**Re: IL Vicino Canteen Brewhouse Kitchen Expansion
2381 Aztec Rd NE
Traffic Circulation Layout
Engineer's/Architect's Stamp dated 6-5-15 (G16-D089)**

Re: IL Vicino Canteen Brewhouse Kitchen Expansion
2381 Aztec Rd NE
Traffic Circulation Layout
Engineer's/Architect's Stamp dated 5-11-15 (G16-D089)

**RE: Traffic Circulation Plan
Il Vicino(G16-D089)**

Re: II Vicino, 2381 Aztec Road NE, Traffic Circulation Layout
Engineer's Stamp dated 10-04-10 (G16-D089)

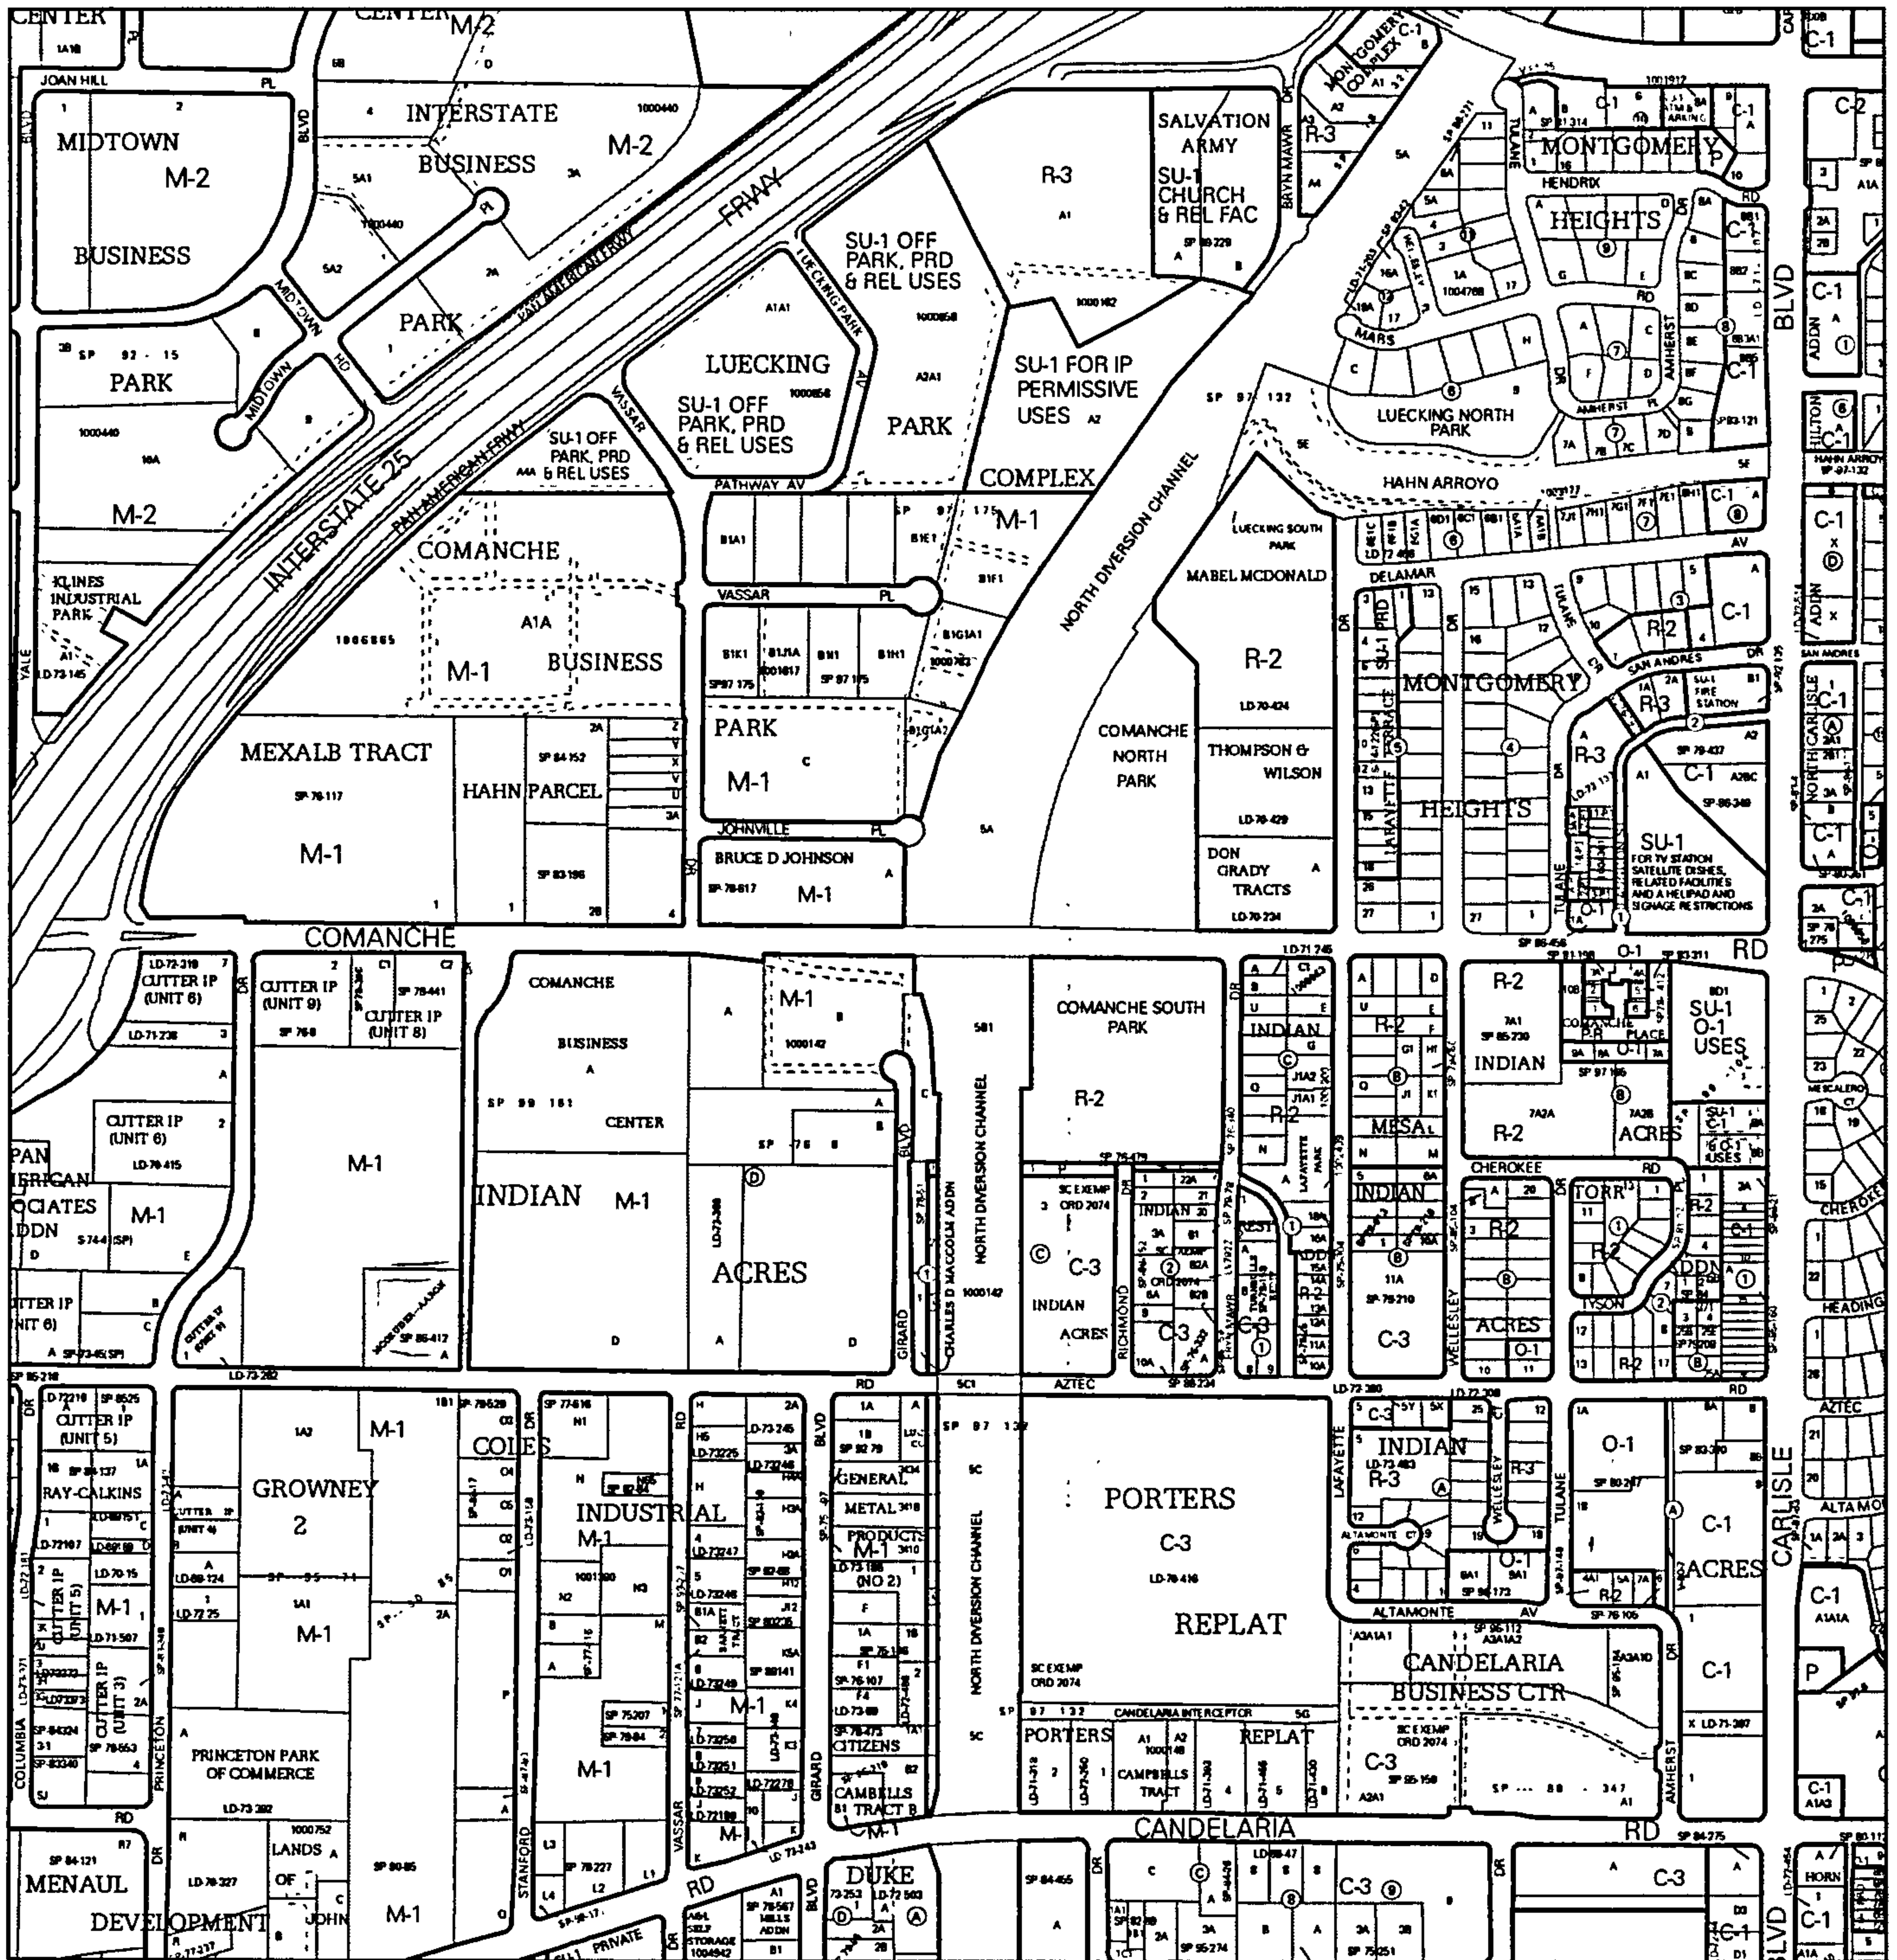
1. A number of symbols and linetypes shown on the plan are not defined. Please revise the legend to define these items.
2. Provide the legal description of the site.

3. Show the entire lot on the plan.
4. Please list the width and length for all parking spaces.
5. A minimum 24-foot wide aisle is required for two directional traffic (a 20-foot aisle is allowed if all stalls are at least 10 feet wide).

6. Call out the aisle width east of the proposed building; an end of aisle island is required in this area.
7. A pedestrian gate is needed at the pedestrian connection to Aztec Road NE.

8. Clearly show the 6-foot wide, ADA accessible, pedestrian pathway from the handicapped parking stalls and from Aztec Road.
9. Is the entire site paved? Please clarify.

10. Show the existing poles along Stanford Drive and Aztec Road.
11. The fence appears to intrude upon the right of way. Please clarify. If an encroachment exists, an encroachment agreement will be required.

12. Where are the motorcycle parking spaces?
13. Please show the location of the nearest driveway on the adjacent lot.
14. Define width of the existing sidewalk.

1. A number of symbols and line types missing

We have added to the legend

2. Provide legal description

We have added the legal

3. Show Entire Lot

I have enclosed copy of ALTA survey describing lot of record. The boundary is correct

4. List width and length of all parking spaces

We have added this, the central parking is 10' and the perimeter along Stanford is 9' and 8.5' on the northern parking.

5. Minimum of 24' isle required unless spaces 10'

These spaces are 10

6. Call out aisle east of building and add island

We have added dimensions and island

7. a pedestrian gate required at street

This has been added

8. Clearly show 6' ADA pathway

**This has been added. This is existing paved area, no removal of change of grades
The lines are for covered outdoor seating overhand**

9. Is entire site paved

**The front is and the back is base course. We are minimizing the required pavement
and only adding at parking spaces per city zoning requirement**

10. show existing pole at along Aztec and Stanford

These have been show

11. fence is intruding in Right of way

Fence will be removed prior to CO or encroachment agreement executed

12. where are motorcycle spaces

These have been added

13. show location of nearest drive on adjacent lot

This has been added

14. Define width of existing sidewalk

This has been added
